GpSpeed MOSFET Insulating Washer Issue

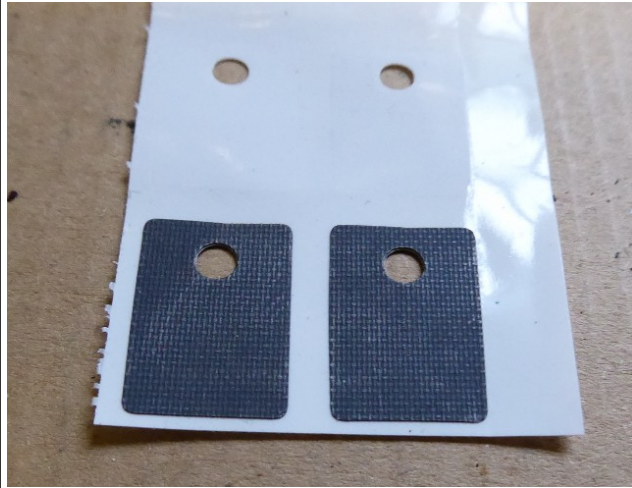
While investigating some issues with a schools GpSpeed controllers, it has come to my attention that there is an issue with the MOSFET insulating pads that some GpSpeed kits were shipped with. Some GpSpeeds have been shipped with white/beige coloured pads and some with black pads as shown below.

The white/beige pads are fine, but the black pads are not fully electrically insulating and can, if the screws are tightened hard (as they should be) cause the MOSFET's/heat-sink to heat up as current will flow through them. Also any burrs at all are likely to cause shorts from the MOSFET to the heat-sink.

If you have these black ones on your GpSpeed controller, I strongly recommend replacing the pads with RS stock number 707-3361 or 169-2177. If you like I can send some to you, just email me with you address and how many you need.
